SERVICE BULLETIN

APPLICABILITY: 2014MY Forester Turbo

NUMBER: 02-152-14R

SUBJECT: Revised Valve Train Parts to Reduce a Warm Engine
 Tapping Sound from the Left Cylinder Head

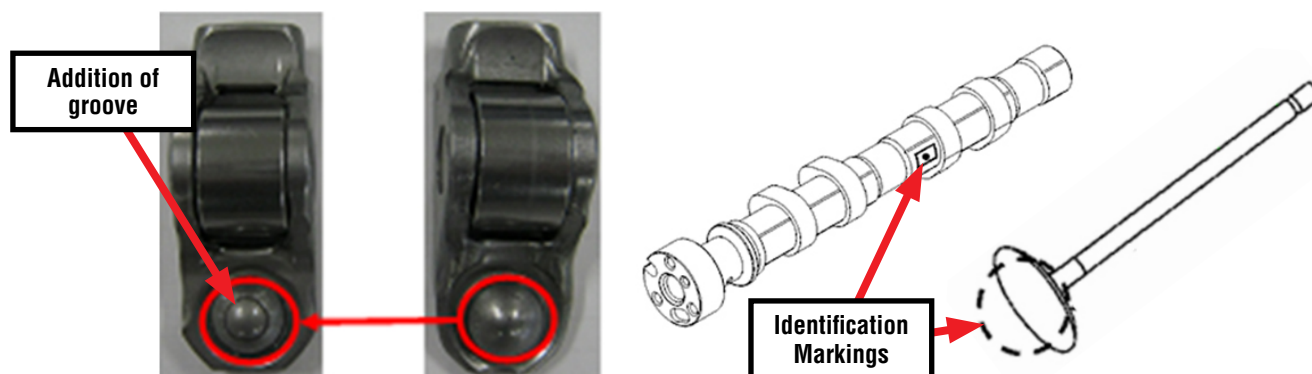
This bulletin announces the availability of revised valve train components developed to reduce a tapping sound (sometimes described as “a sewing machine type” sound) which may be heard coming from the left-hand (B2) side of the engine when the engine is warm. This bulletin does **not** address any cold engine or start-up sounds. The changes consist of:

- Design change to the valve rockers
- Camshaft profile change
- 1.65mm longer intake and 2.45mm longer exhaust valve stem lengths
- Revised rocker pivots were incorporated at the start of 2014MY production

The illustrations below show additional information about the changes to the valve rockers, camshafts and valves to help readily distinguish them from the previous version parts.

PART NAME		NEW	OLD
INTAKE VALVE	Part Number	13201AA670	13201AA640
	Change	Stem Length:	Stem Length:
		104.95mm	103.3mm
Identification	I31	I22	
EXHAUST VALVE	Part Number	13202AA800	13202AA740
	Change	Stem Length:	Stem Length:
		97.9mm	95.45mm
Identification	E3B	E2B	
VALVE ROCKER	Part Number	13249AA250	13249AA240
	Change	Change to Roller Portion	n/a
	Identification	Circular groove added on pivot side	n/a
INTAKE CAMSHAFT, LEFT	Part Number	13037AA970	13037AA840
	Change	Cam Profile Change	n/a
	Identification	38B380	38B240

PART NAME		NEW	OLD
EXHAUST CAMSHAFT, LEFT	Part Number	13052AA970	13052AA840
	Change	Cam Profile Change	n/a
	Identification	53B380	53B240
